Access Compliance Report

Public Rights-of-Way

(Curb Ramps)

Intersection ID: 11266	Main Street: AXAR_RD	Cross Street: MULBERRY_CHURCH_RD	Location: SE
ADA ID: 676A557C898B	Ramp Type: Perp	Initial Pass/Fail: Fail	Overall Compliance: No
Severity Score: 21.25			
Codes/Mitigation Info/Possible Solution		Field Measurements/Component Compliance

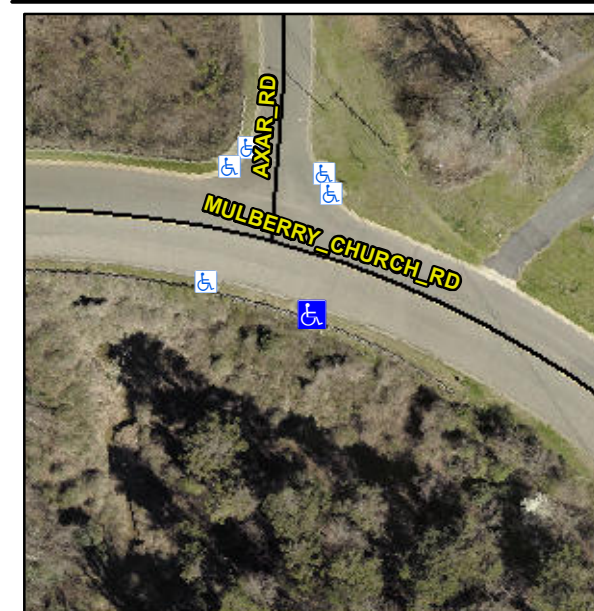
Not Found, R304.5.1, R304.2.2

Compliance	Description	Data	Compliance	Description	Data
N/A	Ramp Length (in)	65.0	No	Ramp Slope (%)	9.3
No	Ramp Width (in)	36.0	Yes	Ramp XSlope (%)	0.1
N/A	Flare Type LT	N/A	N/A	Flare Type RT	N/A
N/A	Flare Slope LT (%)	N/A	N/A	Flare Slope RT (%)	N/A
N/A	Flare Traversable LT?	N/A	N/A	Flare Traversable RT?	N/A
N/A	Landing Length (in)	N/A	N/A	DWS Provided?	N/A
N/A	Landing Width (in)	N/A	N/A	DWS Contrast?	N/A
N/A	Landing Slope (%)	N/A	N/A	DWS Length (in)	N/A
N/A	Landing X Slope (%)	N/A	N/A	DWS Full Width?	N/A
N/A	Landing Curb? (Y/N)	N/A	N/A	DWS Offset (in)	N/A
N/A	Shared Landing?	N/A			
N/A	Gutter Ponding?	N/A	N/A	Gutter Slope (%)	N/A
N/A	Gutter Lip Ht (in)	N/A	N/A	Gutter X Slope (%)	N/A
N/A	Painted X Walk1?	No	N/A	Painted X Walk2?	N/A
	X Walk 1 Direction	To N		X Walk 2 Direction	N/A
N/A	X Walk 1 Width (in)	N/A	N/A	X Walk 2 Width (in)	N/A
	X Walk 1 Slope (%)	6.9		X Walk 2 Slope (%)	N/A
	X Walk 1 X Slope (%)	1.9		X Walk 2 X Slope (%)	N/A

Remove & Replace Entire Ramp.
